Source: Leece-Neville Heavy Duty Systems Division – Arcade, NY

Bulletin No: TSB-1222 **Date:** January 23, 2023

Models: A0014943PGH (4943PGH)

Subject: A0014943PGH to AVI160P2012 / AVI160P2007

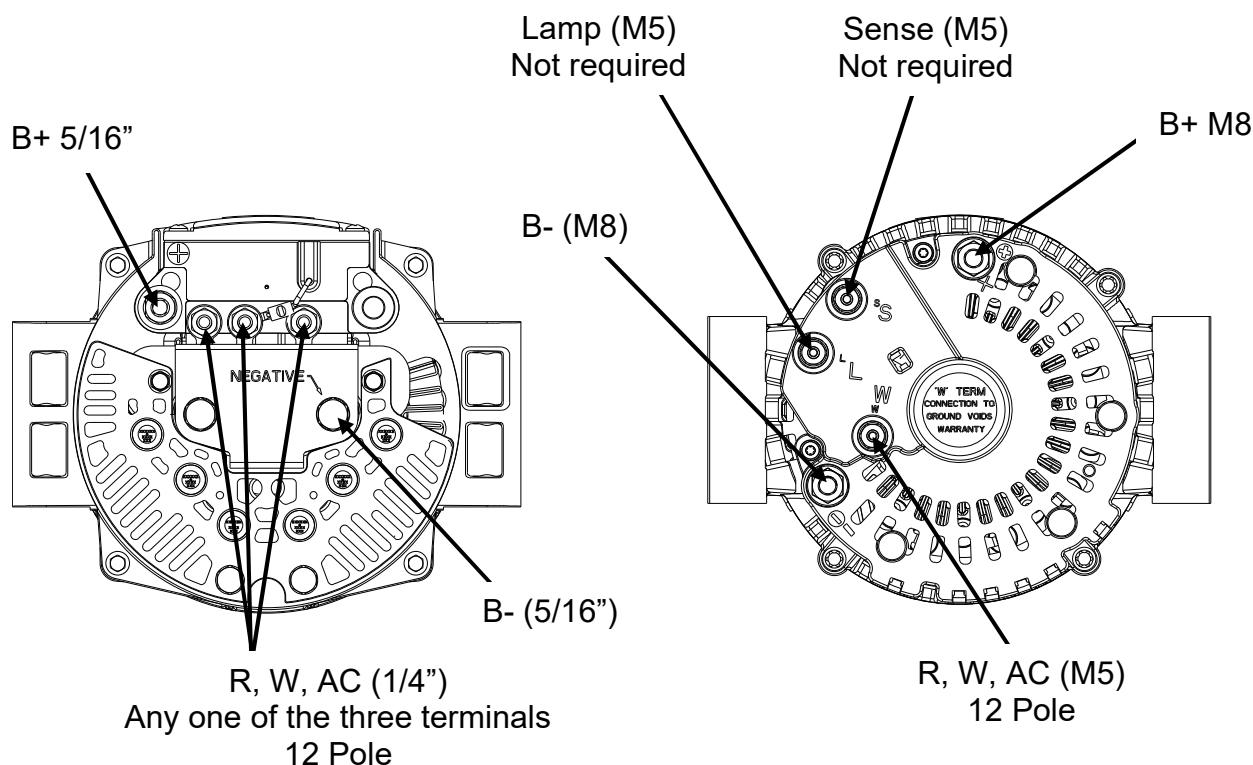
This document will help identify terminal location variances.

Alternator A0014943PGH is discontinued and replaced by a newer AVI160 family of alternators.

For basic operation the AVI160 only requires connections to the B+ and B- terminals.

A0014943PGH is grounded earth return where the AVI160 series replacements are insulated return.

Depending on the vehicle wiring a ground strap may be required.

AVI160 series alternators has a pad mount bracket that uses a short span (108mm) where the series uses a span of (126mm). Most engine brackets have the ability to accommodate both spans. Please verify your engine bracket and refer to TSB-1049 for more information.

Note: AVI160 have internal cooling fans. External fan used on the A0014836LGH is not needed.
